TECHNICAL SERVICE BULLETIN

Number: TSB-FC-2022-011-SC-50

Symptom: Creaking from front of machine Drive Wheel Area

SC50

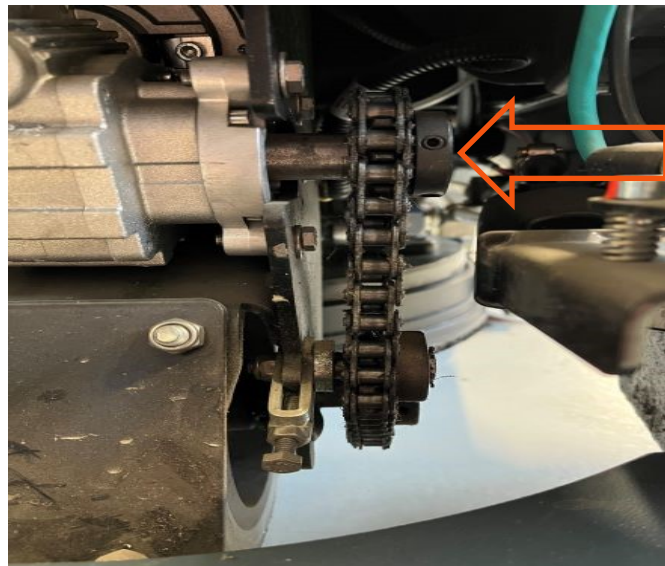
We have had a reported case where the grub screws that hold the chain sprocket on the shaft for the drive chain worked loose causing a creaking noise when driving and the drive chain to be mis-aligned.

A new procedure in production has been introduced to torque, record and calibrate the tools that set the values of the grub screw 56003363 to the correct specification which is 96 in-lb or 10.8 Nm.

SC 50 -Values corrected in production starting from S/N **1000074287**

Please be aware of this and if you have a SC50 exhibiting these symptoms please check this first as it could be the issue or on your regular preventative maintenance visits.
